Access Compliance Report

(Curb Ramps)

Intersection ID: N/A	Main Street: COVINGTON COMMONS DR	Cross Street: REECE VALLEY CT	Location: S
ADA ID: A3C450C0650E	Ramp Type: PerpDiag	Initial Pass/Fail: Fail	Overall Compliance: No
Severity Score: 8.75			
Codes/Mitigation Info/Possible Solution		Field Measurements/Component Compliance

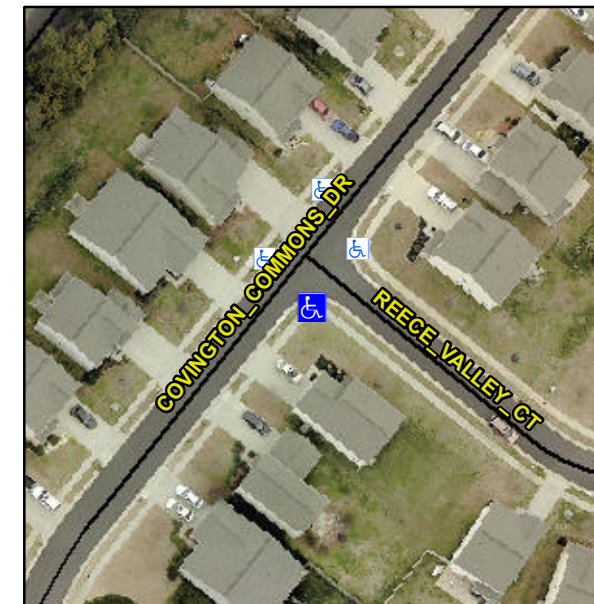
Not Found, R304.5.1

Compliance	Description	Data	Compliance	Description	Data
N/A	Ramp Length (in)	46.0	Yes	Ramp Slope (%)	7.2
No	Ramp Width (in)	47.0	Yes	Ramp XSlope (%)	0.7
N/A	Flare Type LT	N/A	N/A	Flare Type RT	N/A
N/A	Flare Slope LT (%)	N/A	N/A	Flare Slope RT (%)	N/A
N/A	Flare Traversable LT?	N/A	N/A	Flare Traversable RT?	N/A
N/A	Landing Length (in)	N/A	N/A	DWS Provided?	N/A
N/A	Landing Width (in)	N/A	N/A	DWS Contrast?	N/A
N/A	Landing Slope (%)	N/A	N/A	DWS Length (in)	N/A
N/A	Landing X Slope (%)	N/A	N/A	DWS Full Width?	N/A
N/A	Landing Curb? (Y/N)	N/A	N/A	DWS Offset (in)	N/A
N/A	Shared Landing?	N/A			
N/A	Gutter Ponding?	N/A	N/A	Gutter Slope (%)	N/A
N/A	Gutter Lip Ht (in)	1.0	N/A	Gutter X Slope (%)	N/A
N/A	Painted X Walk1?	No	N/A	Painted X Walk2?	No
	X Walk 1 Direction	To NE		X Walk 2 Direction	To NW
N/A	X Walk 1 Width (in)	N/A	N/A	X Walk 2 Width (in)	N/A
	X Walk 1 Slope (%)	2.1		X Walk 2 Slope (%)	3.8
	X Walk 1 X Slope (%)	4.1		X Walk 2 X Slope (%)	2.2

Remove & Replace Curb Ramp With Two New Directional Ramps or Equivalent.
